Problems With The Two-colors 25G Wavelength Plan And A Solution

Eugene (Yuxin) Dai
Cox Communications
IEEE 802.3ca 100G EPON TF
IEEE Interim Meeting
September, 2017
Charlotte, NC, USA

Impacts On Network Deployments

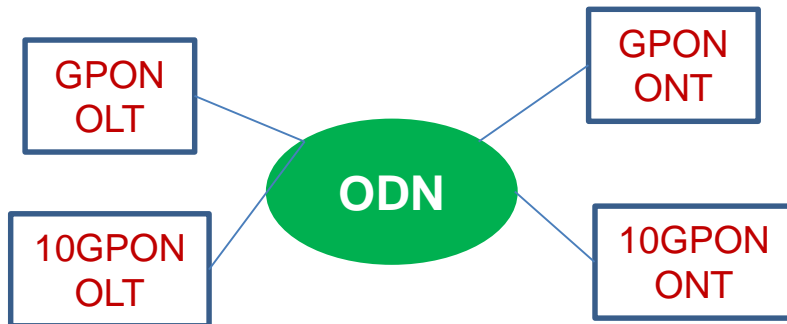
A) Blue 25G(1270nm) coexist with GPON; Red 25G(1310nm) coexist with 10G PON

B) Coexist with 25G is not possible

- **GPON has to be removed from ODN for adding 25G EPON**
- **Or, to avoid the migration problem, don't put GPON and 10G PON on same ODN today**
- **Or, not to deploy 25G EPON**

Neither “blue” nor “red” 25G EPON works for the most common deployment scenario

Impacts Network Evolution and OPEX

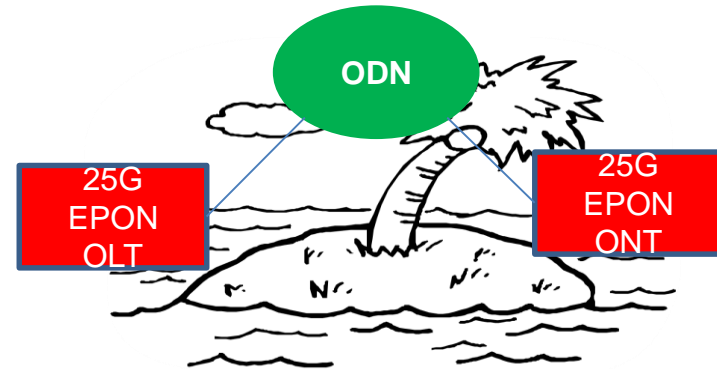
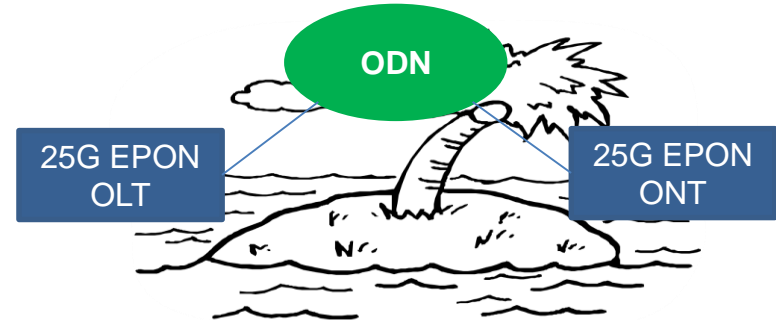
Beginning of evolution: Coexist with 10G PON and GPON with blue and red 25G

End of evolution: Isolated blue and red 25G EPON islands

Operators have to manage isolated blue and red 25G EPON in the network for the lifespan – high OPEX
